# Access Compliance Report

## Public Rights-of-Way

### (Curb Ramps)

Intersection ID: 5646	Main Street: MCCULLOUGH_DR	Cross Street: COLLINS-AIKMAN_DR	Location: SE
ADA ID: CDD58F6C3157	Ramp Type: PerpDiag	Initial Pass/Fail: Fail	Overall Compliance: No
Codes/Mitigation Info/Possible Solution			Severity Score: 22.5
			Field Measurements/Component Compliance

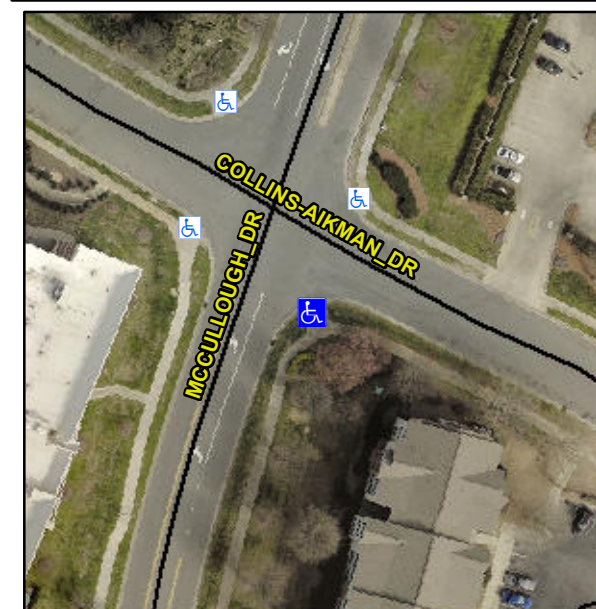
**Not Found, R304.5.1, R304.2.2, R304.5.3**

Compliance	Description	Data	Compliance	Description	Data
N/A	Ramp Length (in)	44.0	No	Ramp Slope (%)	9.5
No	Ramp Width (in)	46.0	No	Ramp XSlope (%)	4.4
N/A	Flare Type LT	N/A	N/A	Flare Type RT	N/A
N/A	Flare Slope LT (%)	N/A	N/A	Flare Slope RT (%)	N/A
N/A	Flare Traversable LT?	N/A	N/A	Flare Traversable RT?	N/A
N/A	Landing Length (in)	N/A	N/A	DWS Provided?	N/A
N/A	Landing Width (in)	N/A	N/A	DWS Contrast?	N/A
N/A	Landing Slope (%)	N/A	N/A	DWS Length (in)	N/A
N/A	Landing X Slope (%)	N/A	N/A	DWS Full Width?	N/A
N/A	Landing Curb? (Y/N)	N/A	N/A	DWS Offset (in)	N/A
N/A	Shared Landing?	N/A			
N/A	Gutter Ponding?	N/A	N/A	Gutter Slope (%)	N/A
N/A	Gutter Lip Ht (in)	N/A	N/A	Gutter X Slope (%)	N/A
N/A	Painted X Walk1?	No	N/A	Painted X Walk2?	No
	X Walk 1 Direction	To NE		X Walk 2 Direction	To NW
N/A	X Walk 1 Width (in)	N/A	N/A	X Walk 2 Width (in)	N/A
	X Walk 1 Slope (%)	0.4		X Walk 2 Slope (%)	6.9
	X Walk 1 X Slope (%)	5.0		X Walk 2 X Slope (%)	0.7

**Remove & Replace Curb Ramp With Two New Directional Ramps or Equivalent.**
